## **CONSERVATION COMMISSION**

### **AGENDA**

**3. Planning Board Earth Excavation Permit Referral:**

PB-2024-20 – 21 & 57 Route 9 – Applicant Granite Engineering LLC, on behalf of owner G2 Holdings LLC, proposes to expand the existing gravel pit located at 21 & 57 Route 9 (TMP#s 215-007-000 & 215-008-000). A Hillside Protection CUP is requested for impacts to steep slopes. Waivers are requested from Section 25.3.1.D & Section 25.3.13 of the LDC related to the required 250' surface water resource setback and the 5-ac excavation area maximum. The parcels are a combined ~109.1-ac in size and are located in the Rural District.

PROJECT No. / DATE: 23-0201-1 / FEBRUARY 3, 2025  
 SCALE: HORIZ. 1"=50'  
 10 OF 22

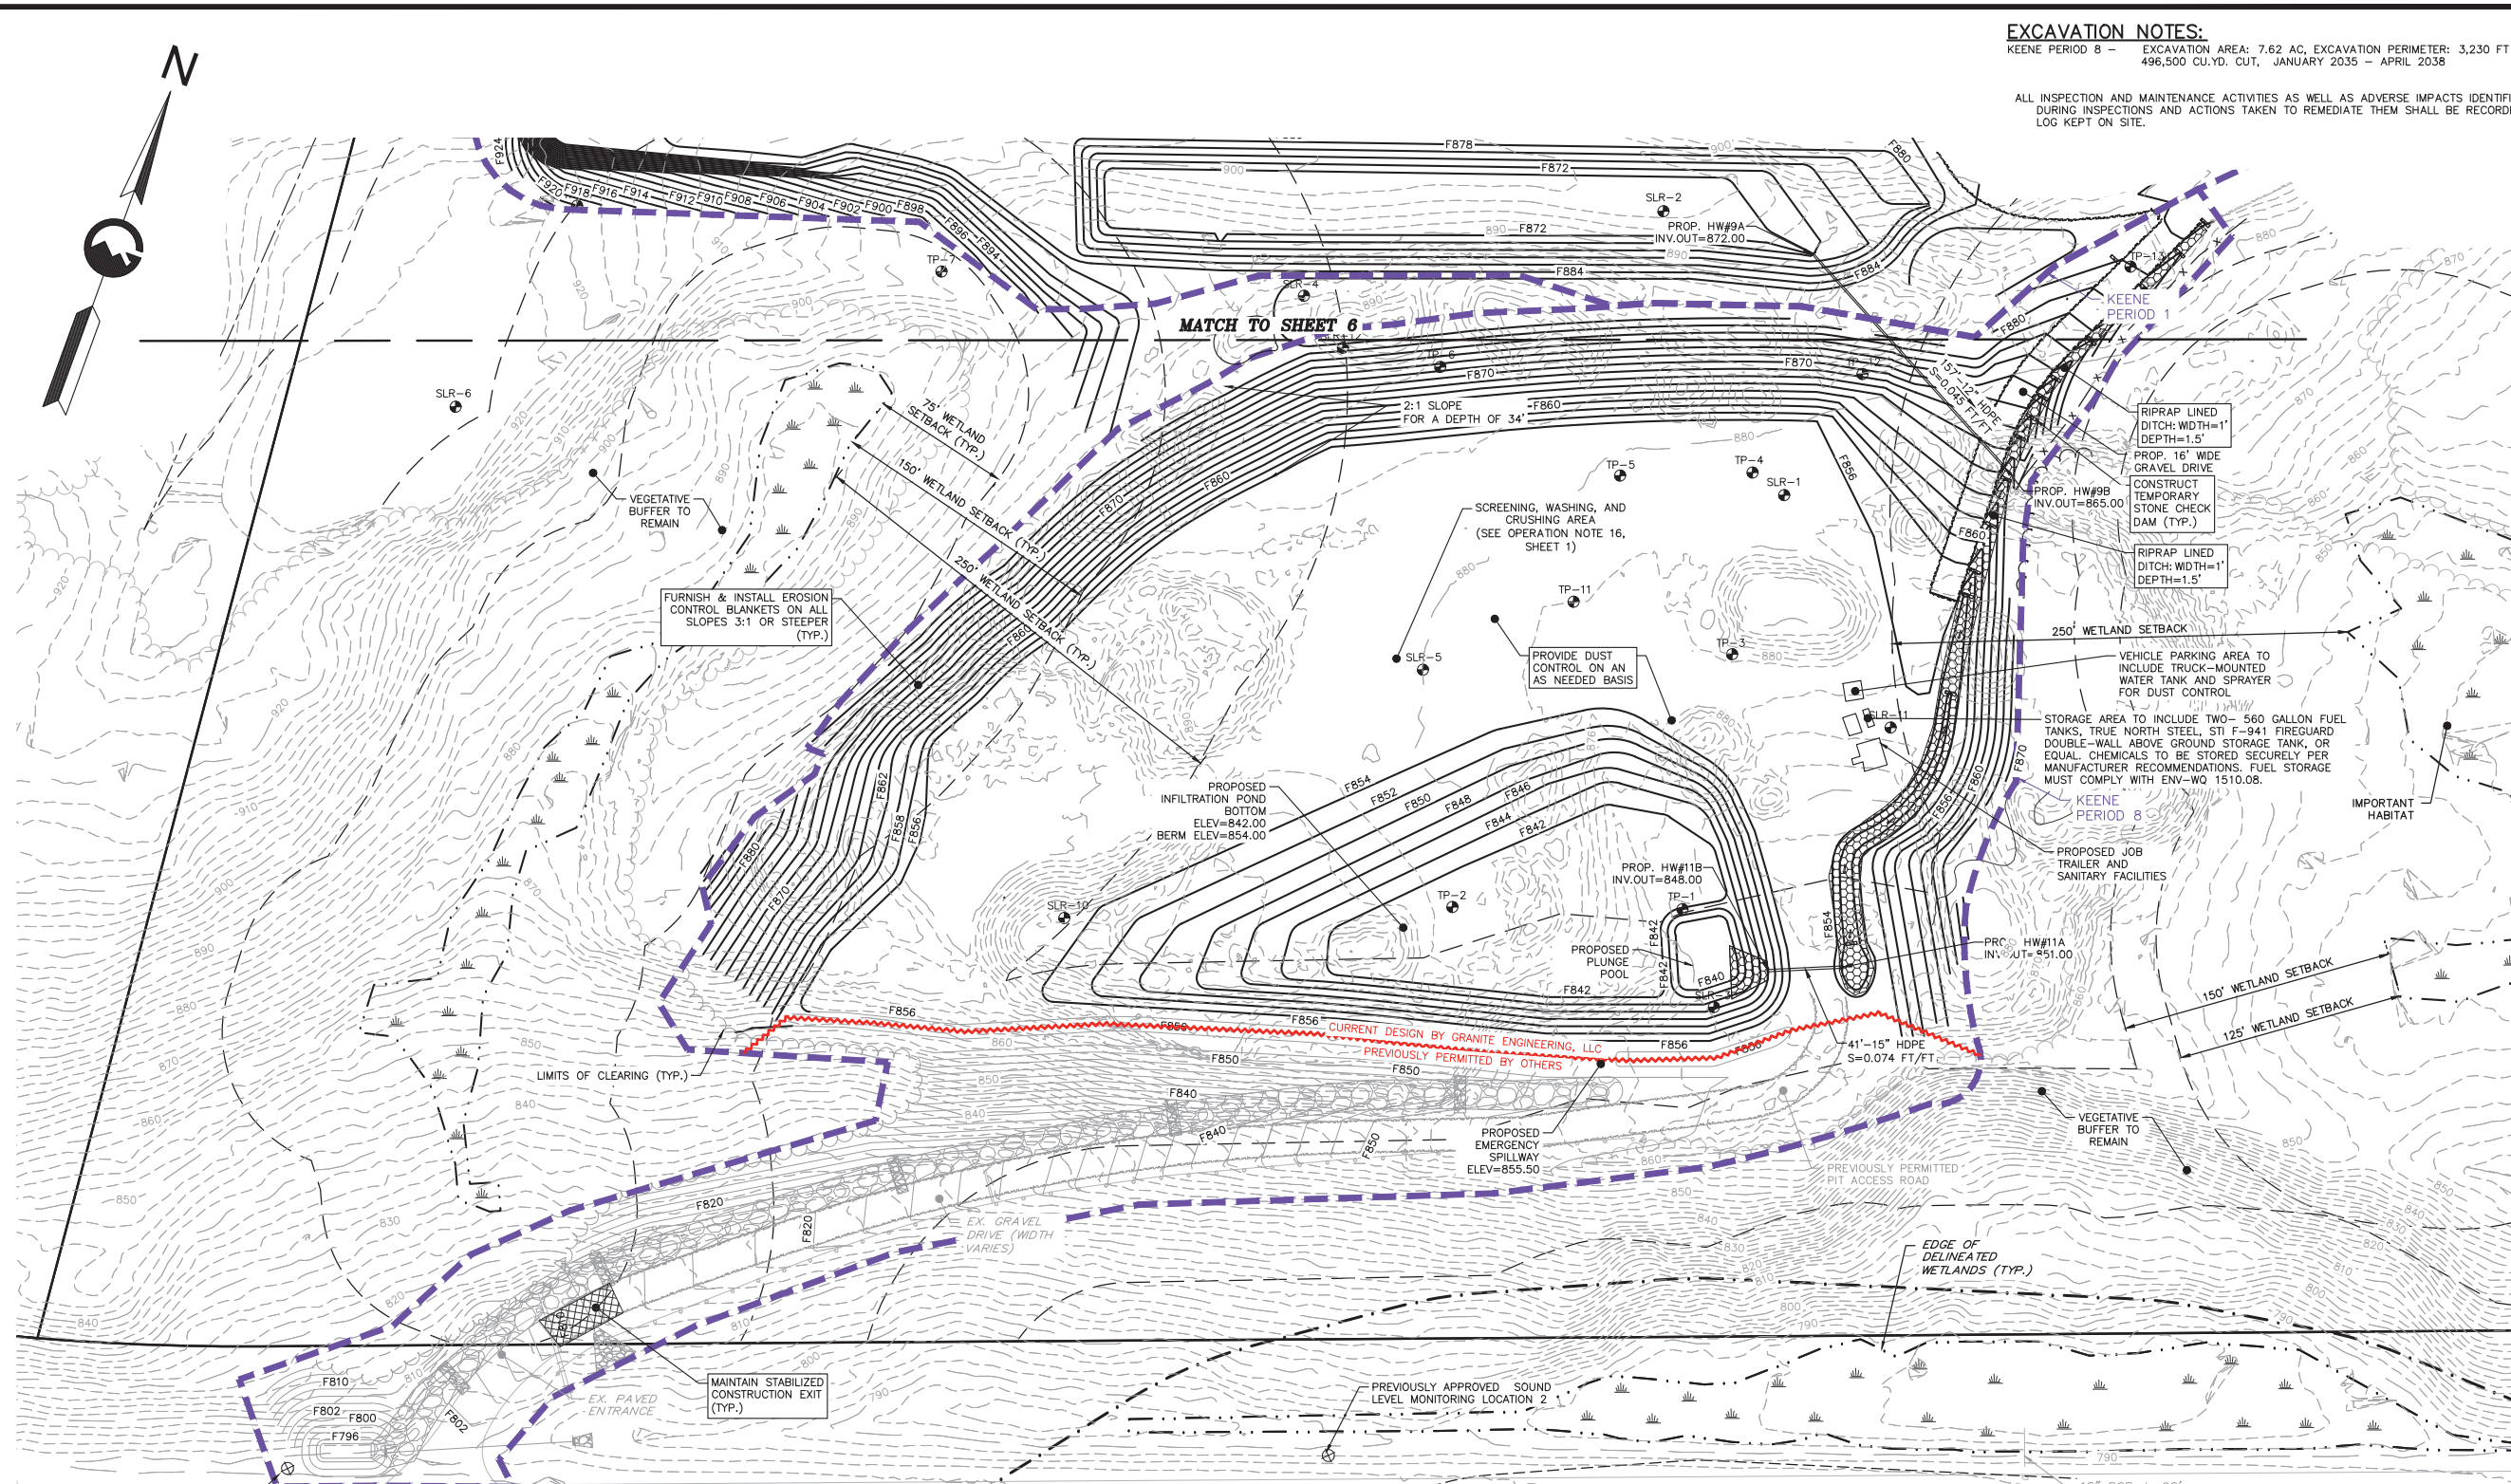
7. Sheet 10 of 22 – What is the plan for transitioning from the temporary basin and into this final design? Reviewing the soils data seems to indicate that the basin design is too low and the excavation in areas will intercept SHWT. It looks like the existing trailer and facilities are in the way and should be moved.

PROJECT No. / DATE: 23-0201-1 / FEBRUARY 3, 2025  
SCALE: HORIZ. 1" = 50'  
page 65 of 110 / 11 of 22

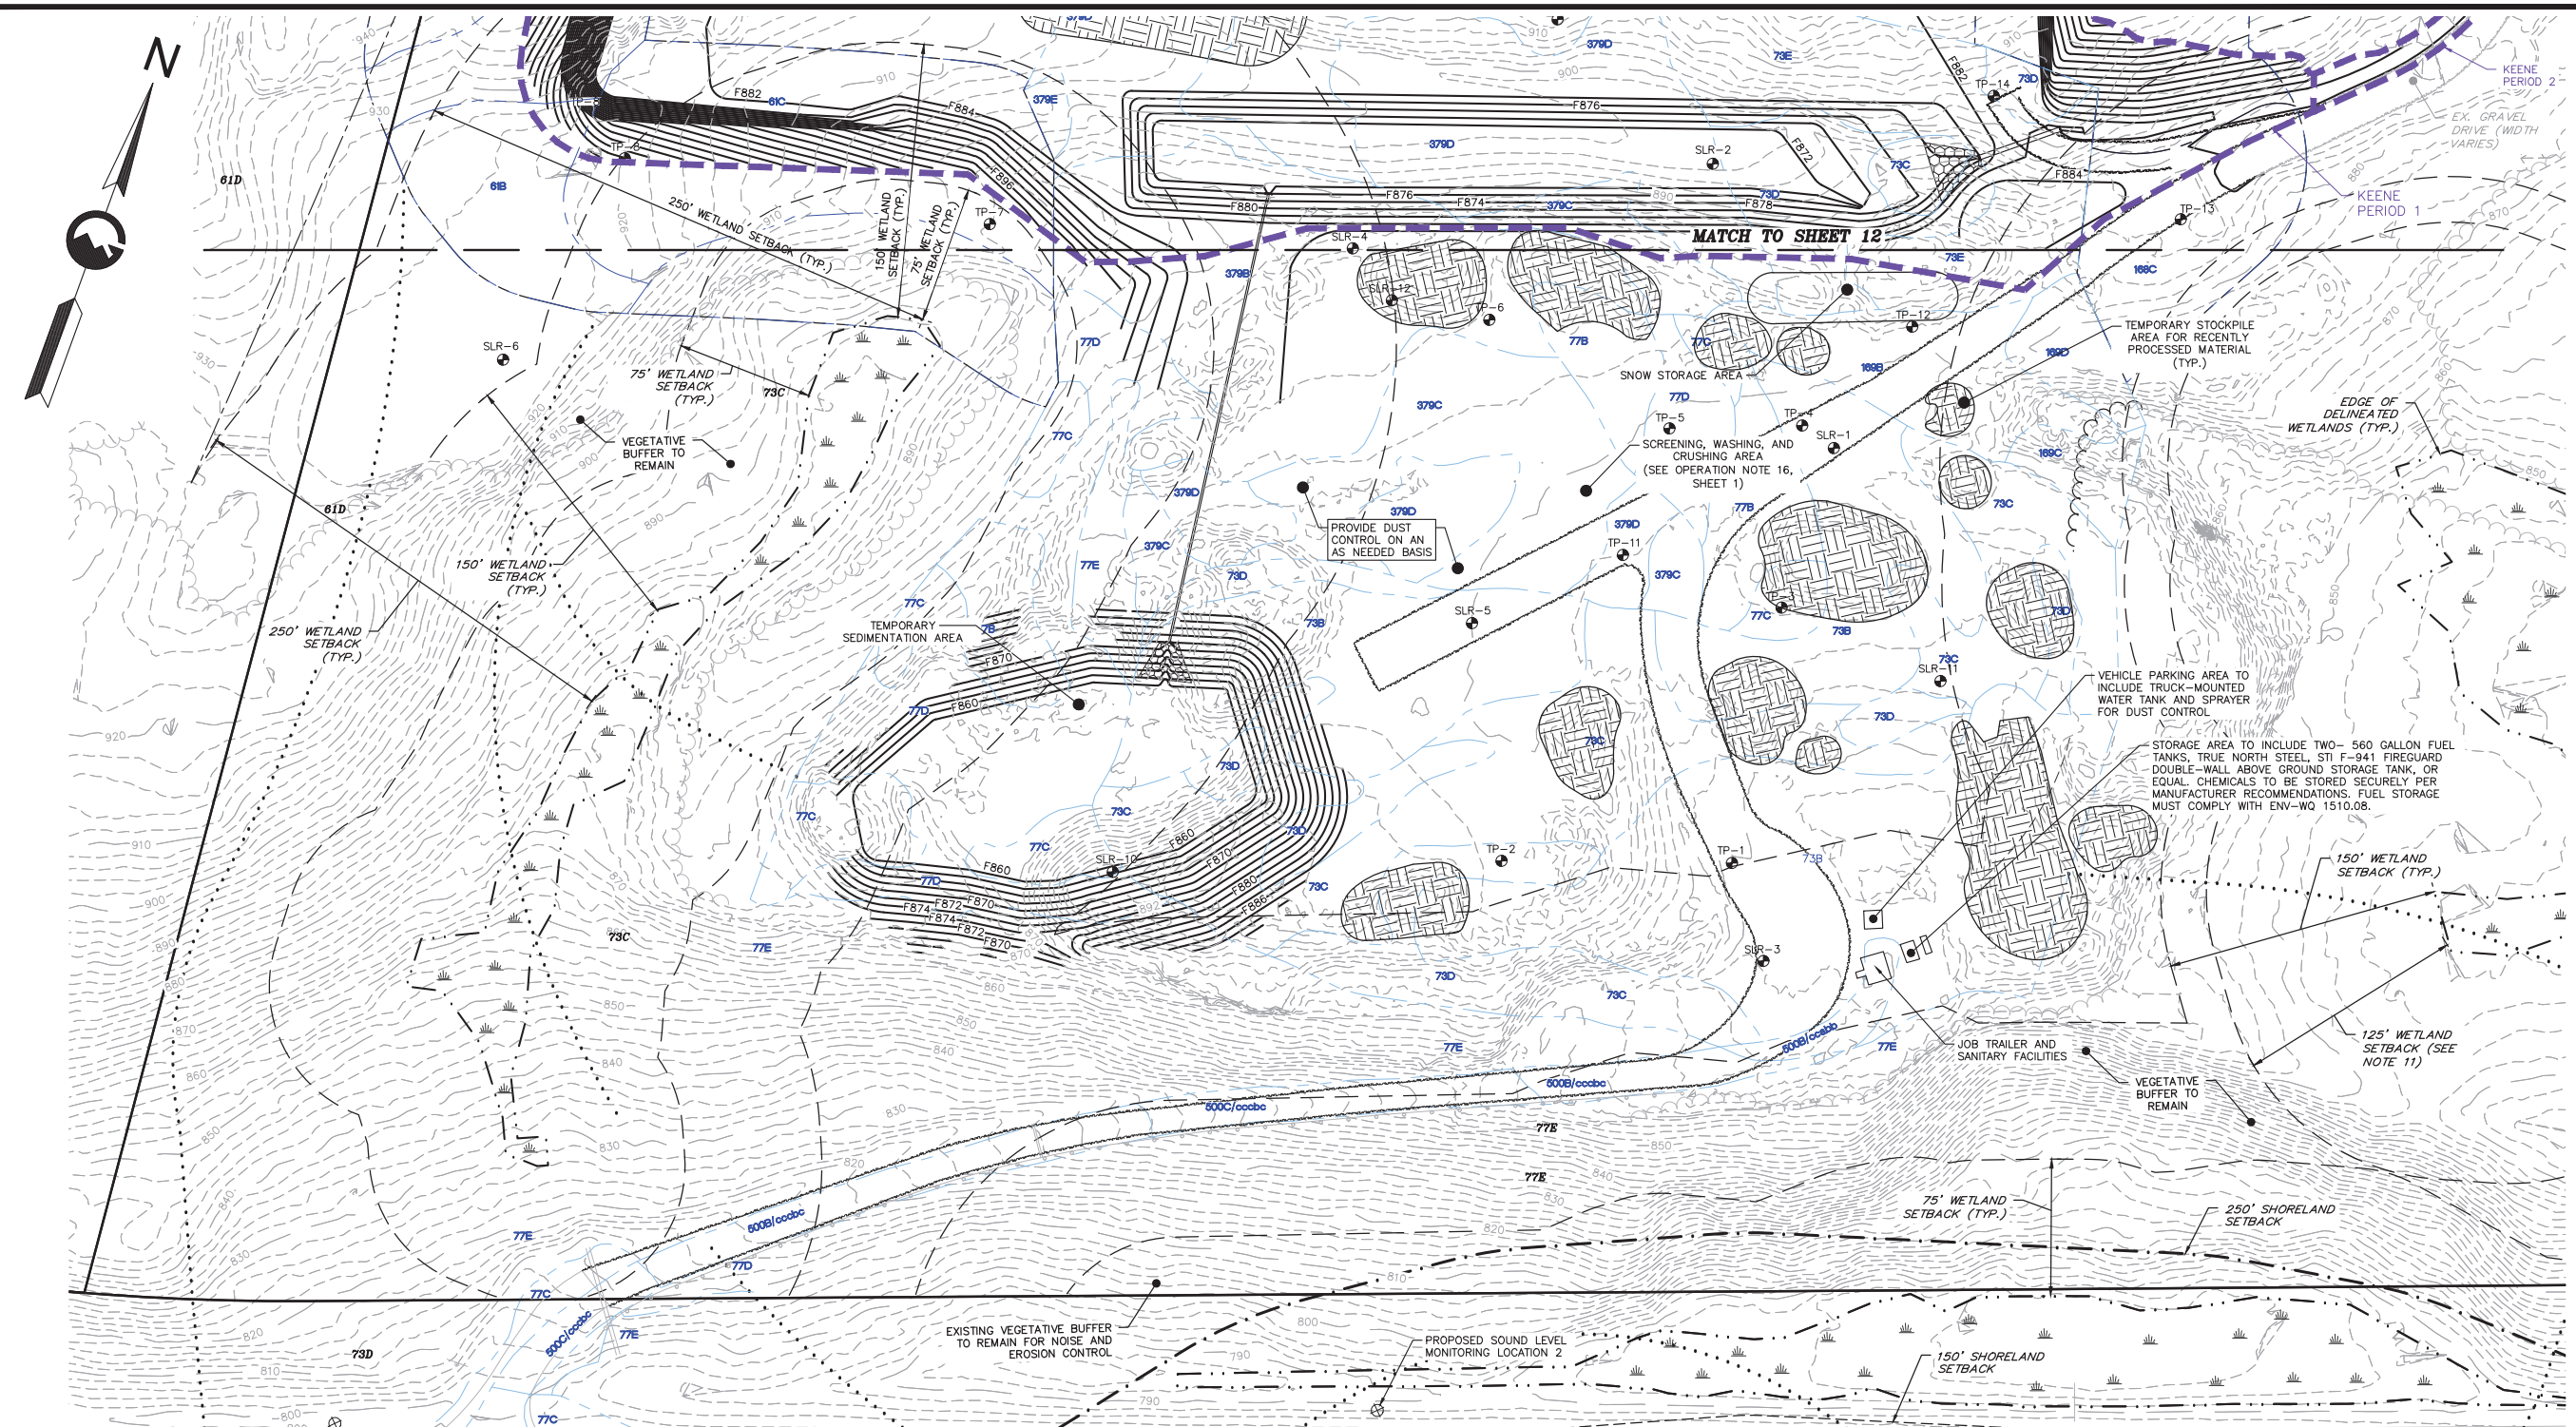
6. Section 25.3.4.A.2: The surface data table on Sheet 11 of 22 does not accurately represent elevations (existing and proposed) and separation to seasonal. The Hydrogeologic Investigation performed by SLR shows that boring log SLR-10 observed water at 840.1+/-, SLR-11 observed water at 817.8+/- and SLR-12 observed water at 888.5+/- . The finish grades in these areas appear to show interference. The plans do not show all of the record borings locations. For example, SLR-12 appears to be missing and the excavation at this location is approximately 855+/- based on what we understand to be its location. This appears to be 30+ feet below the observed seasonal water table.

PROJECT No. / DATE: 23-0201-1 / FEBRUARY 3, 2025  
SCALE: HORIZ. 1" = 50'  
page 68 of 110  
14 of 22

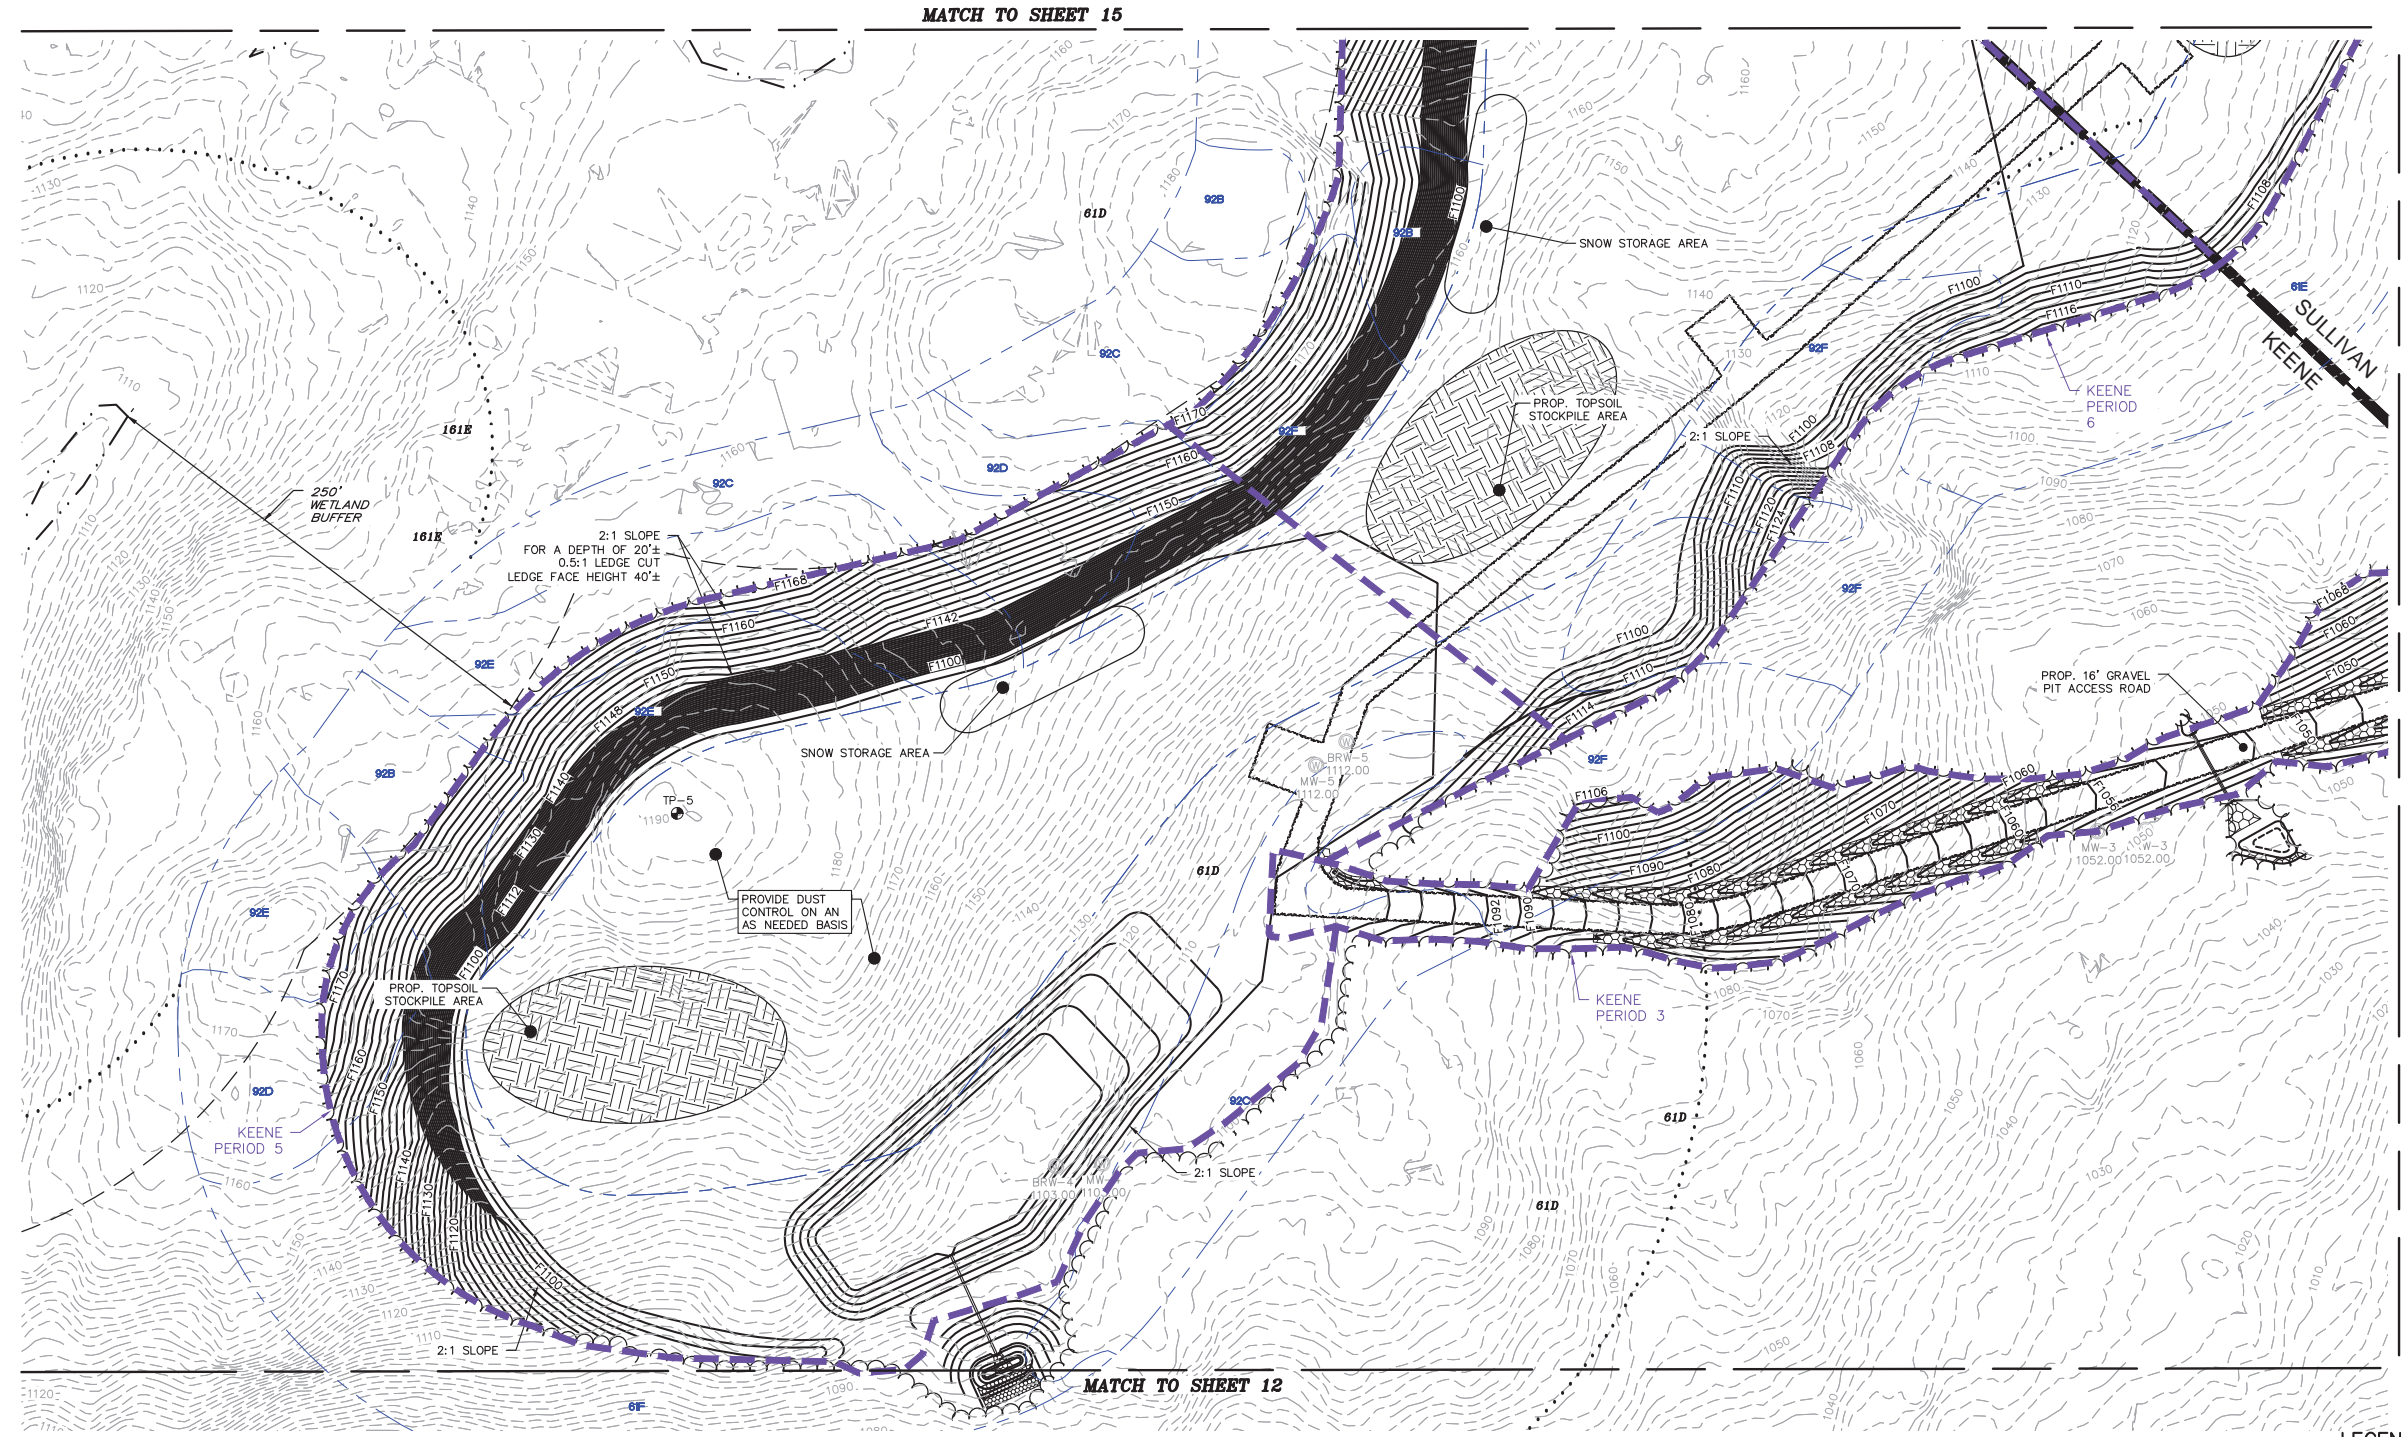
8. Sheet 12 and 14 of 22 – Additional Basin details are needed. Contour labels, berm detail, emergency outlet and associated details.
9. Has an EPA Notice of Intent (NOI) been filed for the current site operations? Please provide appropriate materials so we can verify compliance with the initial approved site plan.
